Detailed Site Plan Royal Farms #381

DSP-20017

SUBJECT: Detailed Site Plan DSP-20017
Type 2 Tree Conservation Plan TCP2-027-2020
Royal Farms #381

PRIMARY MANAGEMENT AREA (PMA) IMPACTS

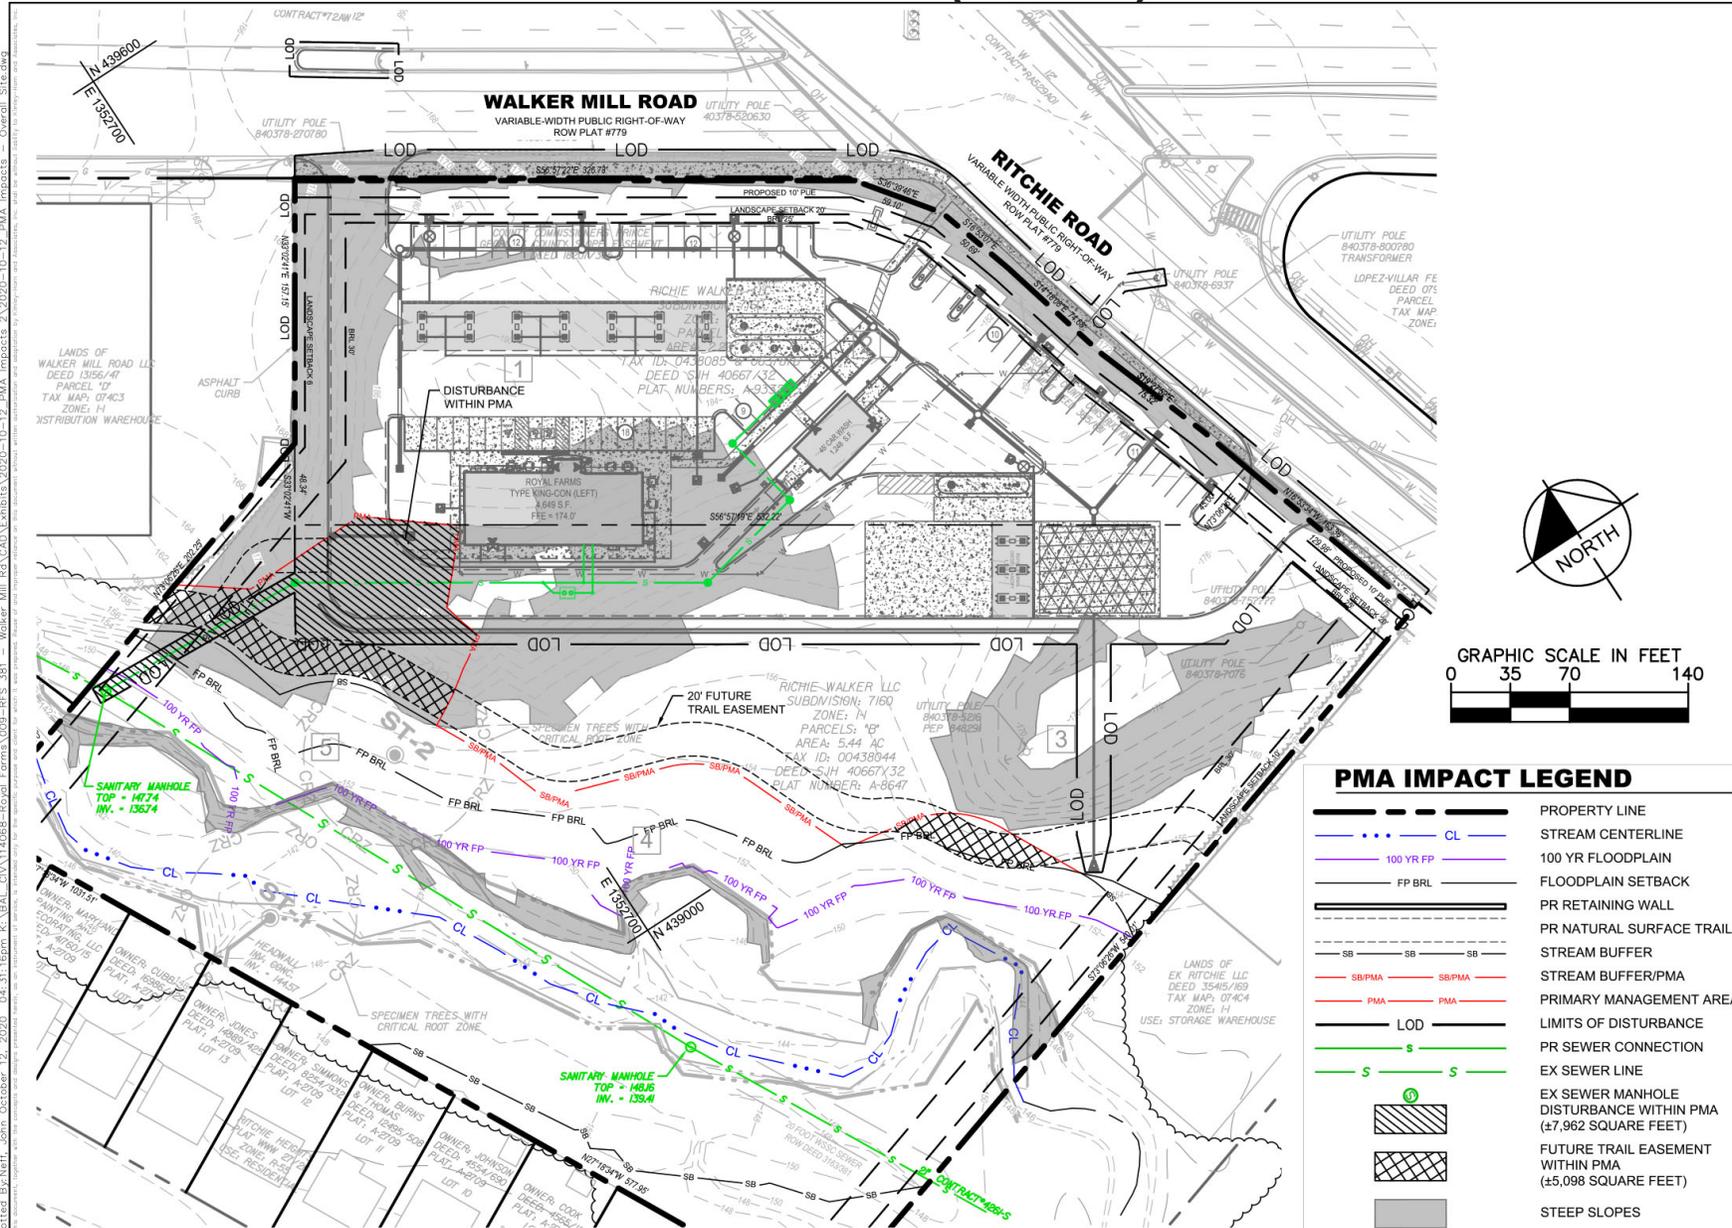
Impact 3 is proposed for the disturbance of 5,098 square feet of PMA for a 20-foot future trail easement. This is a master planned trail connection which staff supports.

- k. Prior to certification of the DSP, the Type 2 tree conservation plan shall be revised as follows:
 - (1) Show the proposed master plan trail easement that overlaps existing woodlands to remain, as being woodland retained counted as cleared on the plan, not as woodland preservation and update the woodland conservation worksheet accordingly.
